Title: **Kintex IO Banks** Approved: No

Project: **CW341**

Title: **CW341 XADC**
 Approved: NO

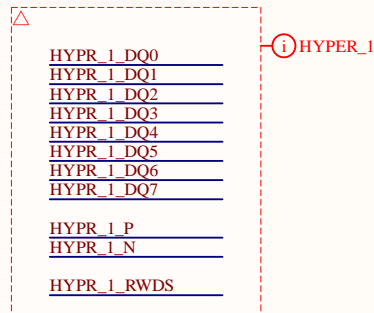
These two net names don't look right..
outputs shared with other op amp?

Oops! Yes they should go to another
XADC input positive channel.
